**TECHNICAL REPORT
TR-NAVFAC-EXWC-EX-1401
SEPTEMBER 2013**

**A BRIEF ENGINEERING ANALYSIS OF THE
PROTOTYPE NEMSCOM MULTIPLE OUTLET
MANIFOLD INTENDED FOR USE WITH THE
SIXCON FUEL TANK ASSEMBLY (NSN 5430-01-
240-4578)**

14. ABSTRACT NAVFAC EXWC provided an engineering analysis regarding the NEPO Engineering Change Proposal (ECP) of 30MAY2012 titled "Addition of Manifold to SIXCON Fuel Tanks." The proposed manifold would allow a single SIXCON Fuel Tank Assembly to simultaneously provide fuel for multiple co-located ground units. The Naval Expeditionary Medical Support Command (NEMSCOM) provided EXWC with two samples of the prototype unit for the analysis. An engineering analysis including recommendations that could lead to a final design are provided.

Figure 2-3. Outlet Configuration #1 with Manifold Installed

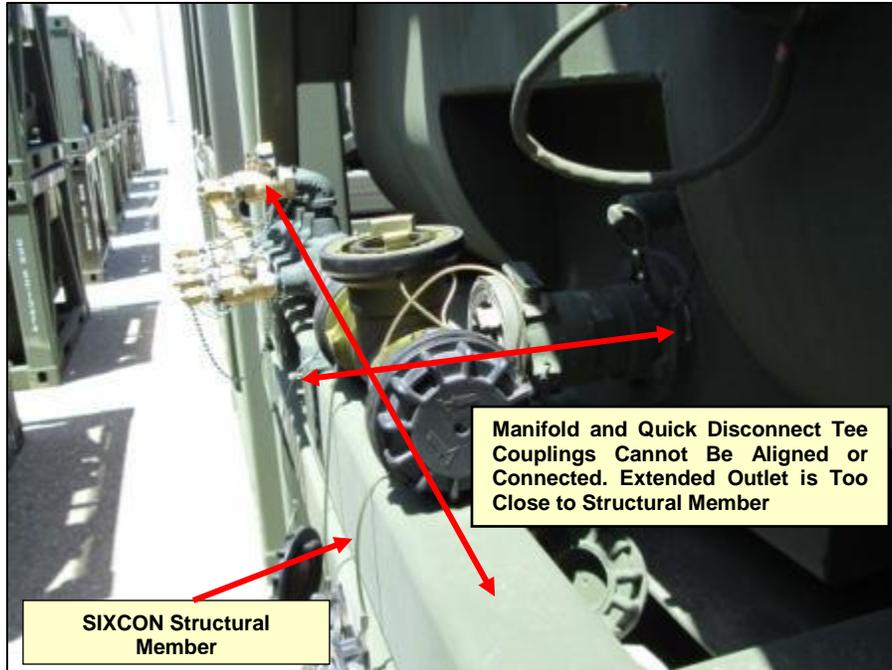
As configured, the three upper outlet valves are positioned well above the lowermost portion of the existing SIXCON tank outlet (see figure 2-3). This configuration reduces the amount of usable fuel that can be gravity-fed to the receiving ground units as compared to that available through the five lower outlet valves. Ideally, the manifold should be configured to provide access at any of the multiple outlet valves to all of the fuel available at the standard SIXCON outlet (i.e. all usable fuel in the SIXCON) rather than limit fuel accessibility at some positions.

Figure 2-8. Inconsistent Contents Markings

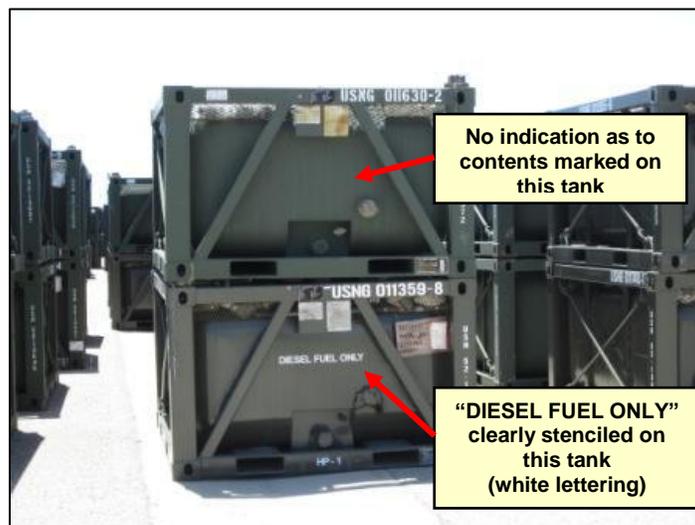
All SIXCONs observed at NBVC had “USMC” stamped on their data tags. (The USMC has a single fuel forward policy and uses JP-8 only.) Some units were stenciled “Diesel Fuel Only”, some stenciled “FUEL ONLY” and others with no markings as to the contents (see figures 2-8 and 2-9). None of the SIXCONs observed were stenciled “JP-8 Only”. It is reasonable to expect that due to the exigencies of warfare and prevailing conditions in service, the manifolds and all components could see service with any of the common fuels used in theater by the Navy/Marine Corps.

Figure 2-10. Outlet Valves

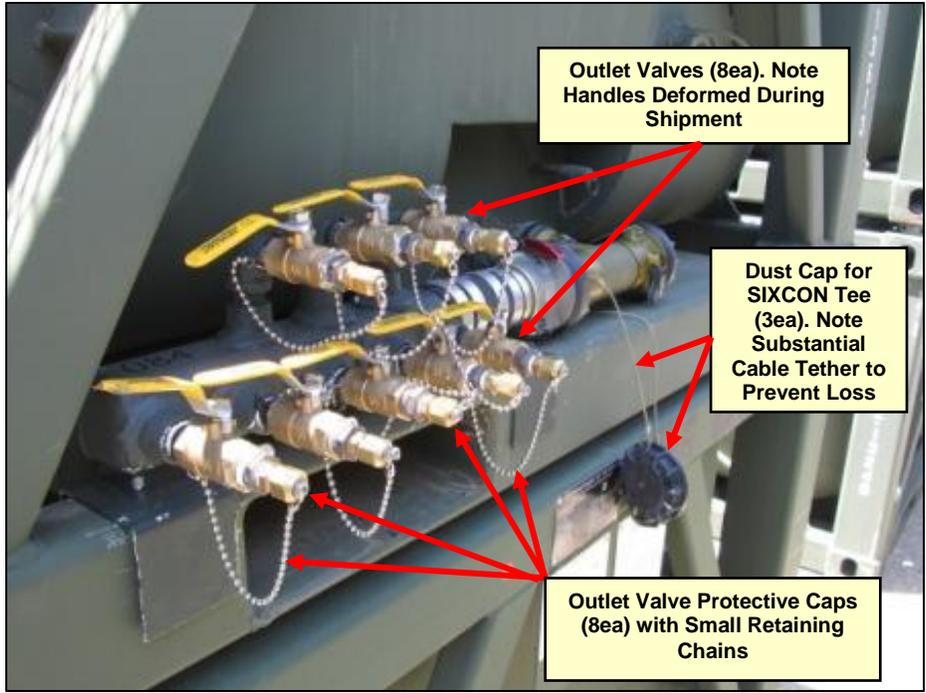
In the absence of any literature, it is unknown for which fluids and pressures the valves are rated. In the absence of engineering data or design criterion, it is unknown as to what pressures the manifold is designed to operate or what safety factors have been observed during design. Outlet valve suitability for use cannot be determined (see figure 2-10).

The handles on the outlet valves are not sufficiently robust for service in the tactical environment. The handles on the unused sample units provided were received bent and misshaped just by the rigors of non-tactical, commercial transport alone. Transport and use in the tactical environment will be significantly more challenging than standard CONUS commercial shipping. Repeated bending and straightening will lead to handle failures, which would in turn render the individual valve unusable.

It is understood that the NEMSCOM prototype manifold was fabricated with flared fittings on the outlet valves to expediently interface with a readily available fuel hose, NSN 4720-00-021-3320. This configuration does not seal either the valve or hose when disconnected. To reduce the possibility of a fuel spill if frequent connections/disconnections are anticipated (no information on the frequency of connections/disconnections was provided) the flared outlet ports on the outlet valves as well as the connecting ends of the hoses, should be fitted with suitable dry-break couplings..

The small retaining chains on the outlet valve protective caps and their attachment means (plastic wire-ties) are not sufficiently robust for the tactical environment and will likely fail in service. Loss of the outlet valve protective caps will ultimately lead to damage to the threads and flared ends of the outlet valve fittings, rendering them unusable. All outlet valve protective caps should have retaining cables or tethers of similar size and strength to those utilized on the large dry-break manifold inlet valve dust cap, the SIXCON outlet valve dust cap, and the SIXCON quick disconnect tee dust caps to prevent loss.

Figure 2-11. Bleed Ports with Removable Bleed Port Caps

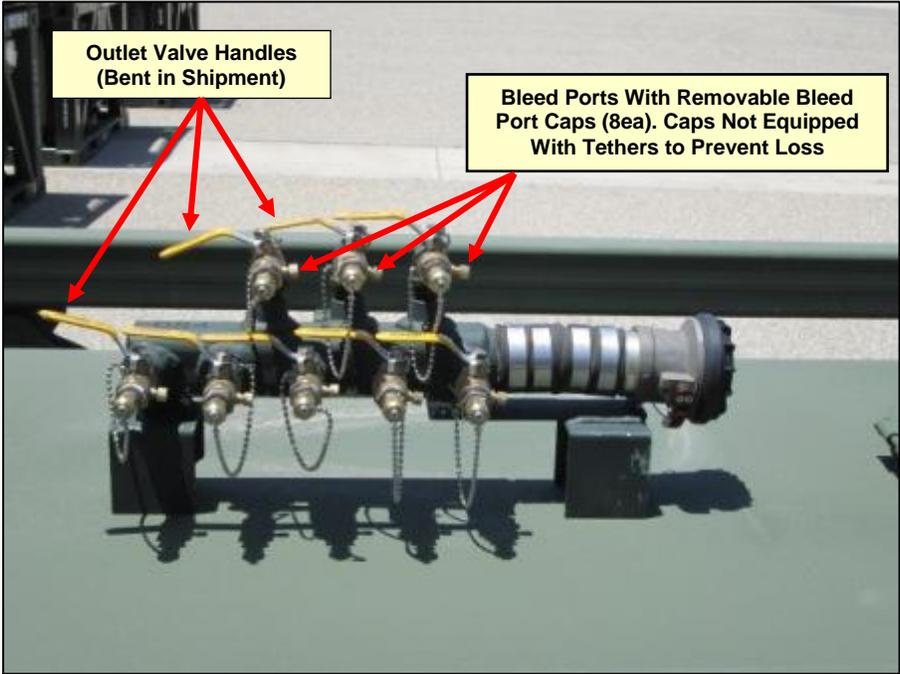
The outlet valves have small caps on the side, which cover what are apparently air bleed, sensor access (pressure, temperature, etc.) or perhaps sampling ports (“bleed ports”) (see figure 2-11). The author is unaware of a useful purpose for the bleed ports in this application and concerned about them providing a potential leakage path. A leakage path could either introduce air into the outlet lines (which would typically be connected to the suction side of a ground unit fuel pump) or result in a fuel spill with the associated hazards. If there is indeed no requirement for the bleed ports and accompanying caps, it is recommended they be eliminated.

The small bleed port caps have gaskets inside made of unknown material. If bleed ports and caps must be included on the unit for function as determined by the end user, it should be insured that the bleed port cap seals (as well as the outlet valves themselves) are made of materials compatible with any fuel to which they could possibly be exposed in the field. This should include as a minimum DL-2, JP-5 and JP-8.

The bleed port caps do not have any form of retaining means to prevent loss. If the bleed port cap from any valve is lost, that valve then becomes unusable. All bleed port caps (again, if bleed ports and caps are necessary for function as determined by the end user) should have retaining cables or tethers of similar size, strength and attachment means to those on the large dry-break manifold inlet valve dust cap, the SIXCON outlet valve dust cap, and SIXCON quick disconnect tee dust caps to prevent loss.
